TSB Number:	146-001-2022D		
Product:	Inverted Gear Rack In-Wall Slide-Out System manufactured between October 2021 and January 2022		
Date:	Aug. 26, 2024	Labor Rate:	3.4 Hours Allowed (1.7 hours per side)

Purpose

This document is to address the concern of the increased frequency of Schwintek slide systems becoming inoperable in the identified time frame.

Kit will include:

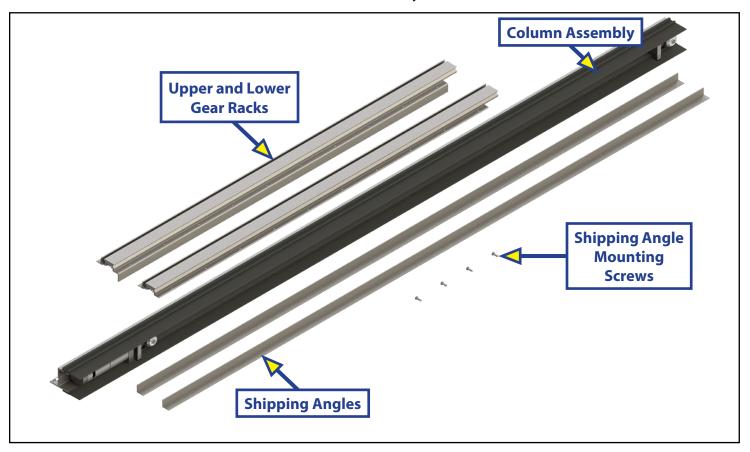
Systems will be shipped partially disassembled in a box or tube.

NOTE: Fixed side shown, kit will include Float side assembly as well.

NOTE: The kit includes replacements for both the fixed and float sides of the system. It is important to replace BOTH sides and use ALL of the components.
